**Written submission from the
Manitoba Métis Federation**

**Regulatory Oversight Report on the
Use of Nuclear Substances in
Canada: 2023**

Commission Meeting

November 7, 2024

Figure 2. Summary of Radiation Protection SCA compliance inspections. Adopted from CNSC 2023. ROR on the Use of Nuclear Substances in Canada.

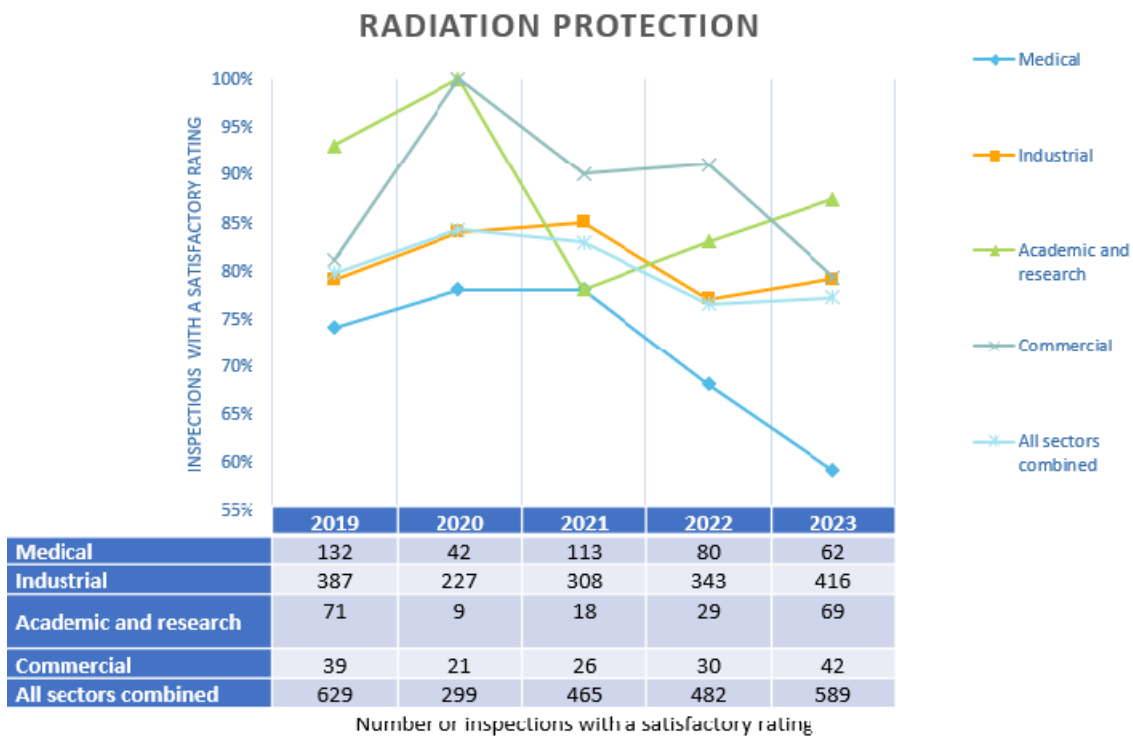
Since 2020, there has been a steady decline in performance as it relates to the Radiation Protection SCA within the medical sector (Figure 2). CNSC have identified that a contributing factor in the declining performance was a series of amendments which were made to the *Radiation Protection Regulations*, as well as REGDOC-2.7.1, Radiation Protection, and REGDOC-2.7.2, Dosimetry. Barriers within the medical sector, have challenged the adoption of revised radiation protection measures. In recognizing these factors, the MMF suggests that in introducing these new measures, licensees were not proactively prepared to adopt them, requiring reactionary measures from the CNSC to address performance issues only after they were observed.

With respect to the efforts made by the CNSC to address performance issues within the medical sector following the 2023 directive, the MMF recommends that CNSC establish a monitoring feedback loop to determine the effectiveness of performance improvement initiatives beyond inspections and ROR reporting. This feedback loop would focus on monitoring and evaluating the effectiveness of CNSC initiatives through the examination of licensee engagement with performance improvement initiatives or resources. This monitoring feedback loop should also be used to assess licensee preparedness for regulatory change in advance of regulatory amendment, effectively determining likelihood for success in amendment implementation and industry adoption, as well as guide the need for additional proactive development or support resources.
